NAME FITTING-HULL-BULKD #5 LOWER -FORGING

CONSOLIDATED AIRCRAFT CORP. SAN DIEGO CALIF

J 28B5508

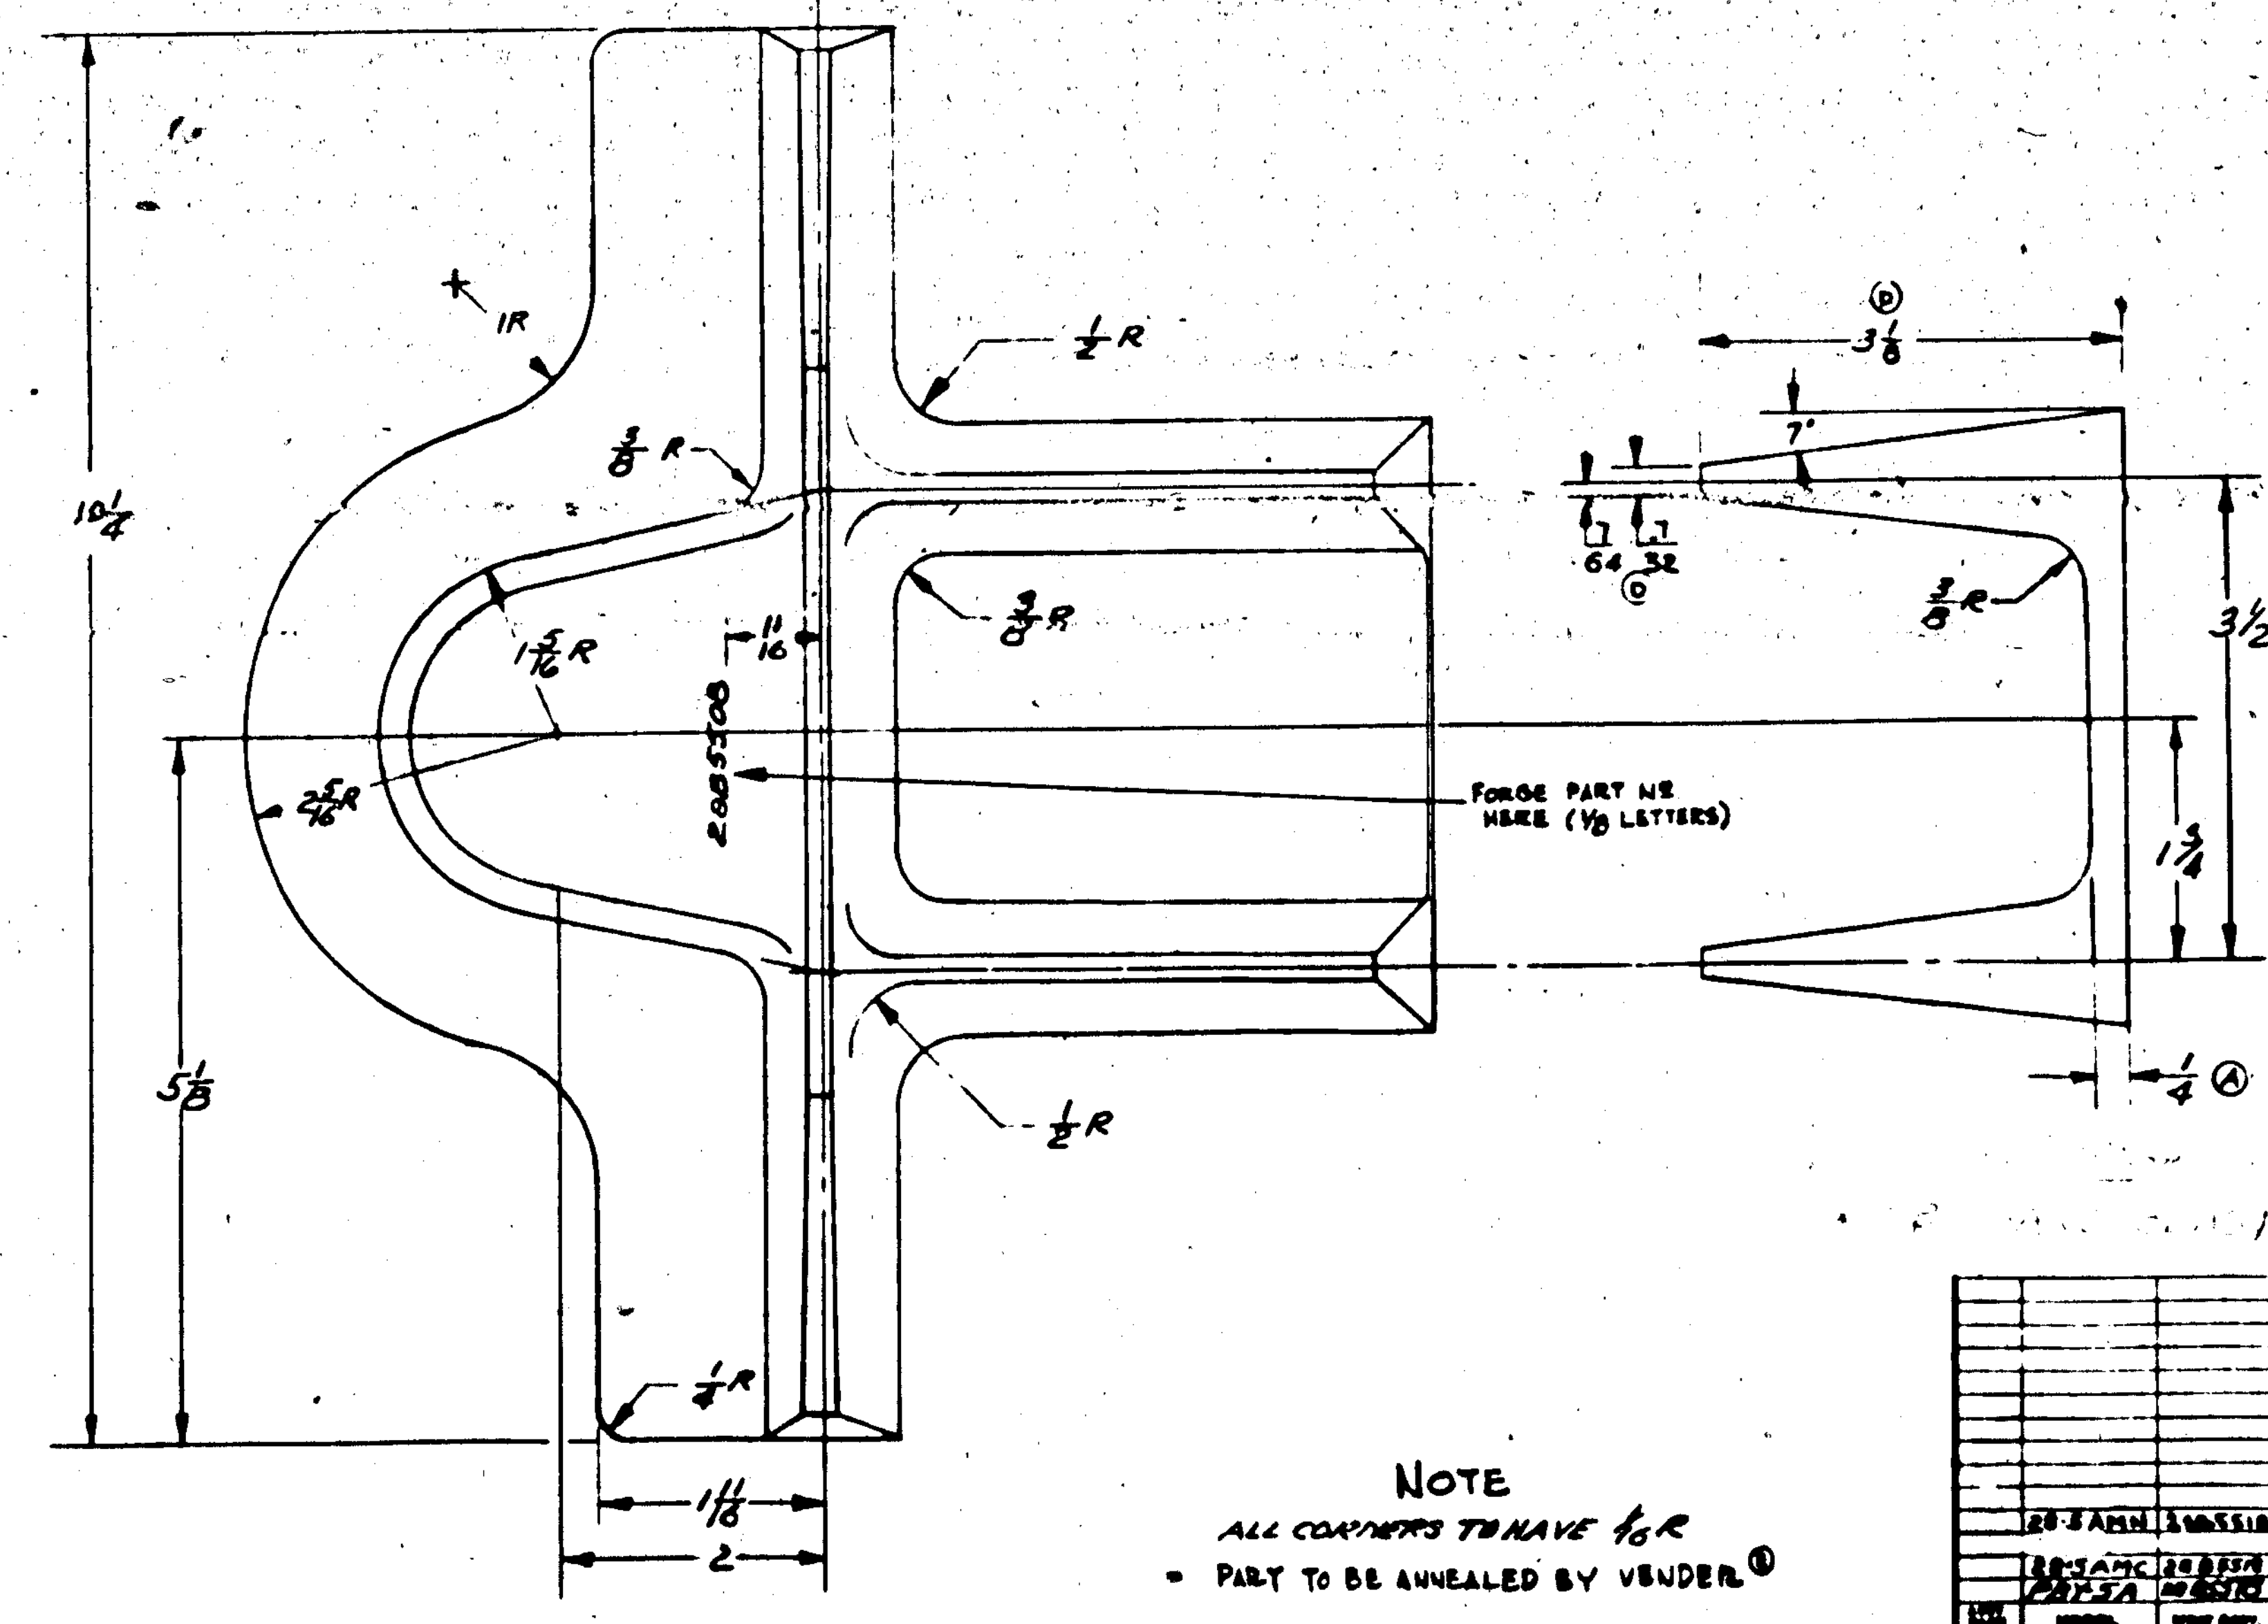
| LET | ALTERATION | DATE | BY | LET | ALTERATION | DATE | BY |
|---|---|---|---|---|---|---|---|
| A | 1/4 DIM WAS 1/8 | [illegible] | [illegible] | | | | |
| B | 5/16 DIM WAS 1/8 | | | | | | |
| C | CHG DRAFT & [illegible] | [illegible] | [illegible] | | | | |
| D | [illegible] | 2-22-41 | [illegible] | | | | |
| E | REMOVED [illegible] HOLE BEFORE HEAT TREAT & TO BE HEAT TREATED TO [illegible] P.S.I. BY PURCHASER FROM NOTE "PART TO BE ANNEALED BY VENDOR" [illegible] | [illegible] | [illegible] | | | | |
| F | ADD MATL NOTE [illegible] | [illegible] | [illegible] | | | | |
